Serial: RNP-RA/15-0053

**H. B. ROBINSON STEAM ELECTRIC PLANT, UNIT NO. 2  
DOCKET NO. 50-261/RENEWED LICENSE NO. DPR-23**

**Subject:** Compliance Letter and Final Integrated Plan in Response to the March 12, 2012 Commission Order Modifying Licenses with Regard to Requirements for Mitigation Strategies for Beyond-Design-Basis External Events (Order Number EA-12-049) For H. B. Robinson Steam Electric Plant, Unit No. 2

**RESPONSE TO NRC STAFF OPEN ITEM AQ-61  
FOR  
H. B. ROBINSON STEAM ELECTRIC PLANT, UNIT 2  
MITIGATION STRATEGIES INTEGRATED PLAN, REVISION 1**

Figure 1, Tornado Travel Path & Debris Locations

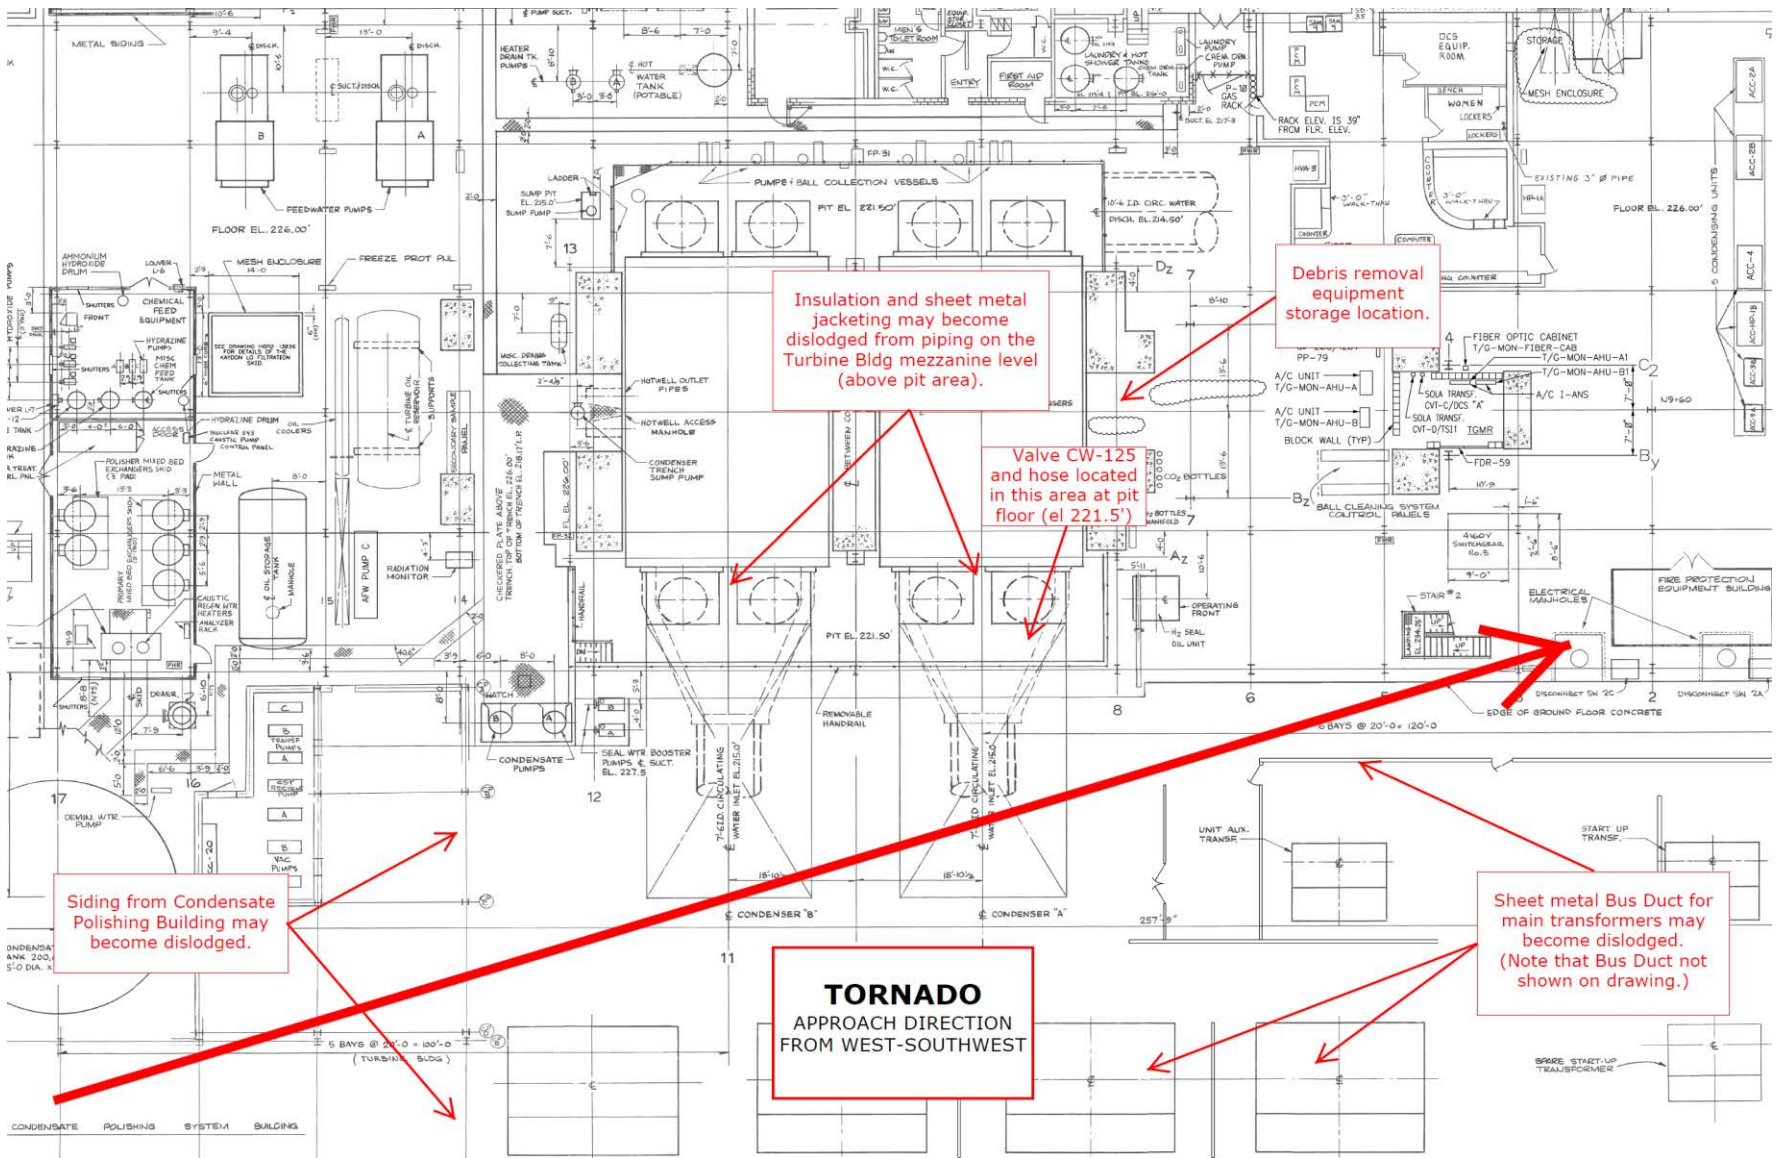
During the NRC Audit of March 2-6, 2015, regarding Audit Question 61, Steam Generator Dryout, The NRC Fukushima Flex Audit team questioned the Robinson strategy for providing water from the Circulating Water system after a high wind event. The NRC question centered on debris that might be deposited near the water source after a high wind event. Debris may limit accessibility to the new valve CW-125 and the associated hose assembly located in the

condenser waterbox pit area. Limited accessibility may challenge the ability to respond to the event within the 61 minute time allotted for response.

Figure 1, Tornado Travel Path & Debris Locations, shows a plan view of the area around the condenser waterbox pit. The most probable tornado approach direction is from the west-southwest. Based on the attachment drawing, a walkdown was performed to identify any potential debris not mentioned in the above evaluation. The walkdown verified heavier items in Table 1 were located near the condenser waterbox pit. No new items were found. The walkdown determined miscellaneous construction materials may be in the area south and east of the condenser waterbox pit. These materials are listed as items 7 through 13 in Table 1.

An engineering evaluation (EC99828, Debris Removal At New Circ Water Valve For FLEX Pump (Reference 9)) was performed to characterize debris type and weight that may be located in the condenser waterbox pit area following a high wind event (See Table 1). Light weight loose debris may be deposited over valve CW-125 and the associated hose assembly. The debris may block access to the valve and hose. The evaluation also determined the equipment needed to remove debris to access valve CW-125 and hose assembly.

Table 1 proves most debris weight will be less than 50 pounds for any single item. The heaviest debris will be the composite panels at 137 lbs. All debris can be removed by hand to clear the CV-125 valve and hose location. Debris blocking access to the flex connection simply needs to be moved to clear access. Immediately after the high wind event, flex equipment mobilization is the priority, not plant clean up. As such, any debris blocking the valve will only need to be moved a few feet.
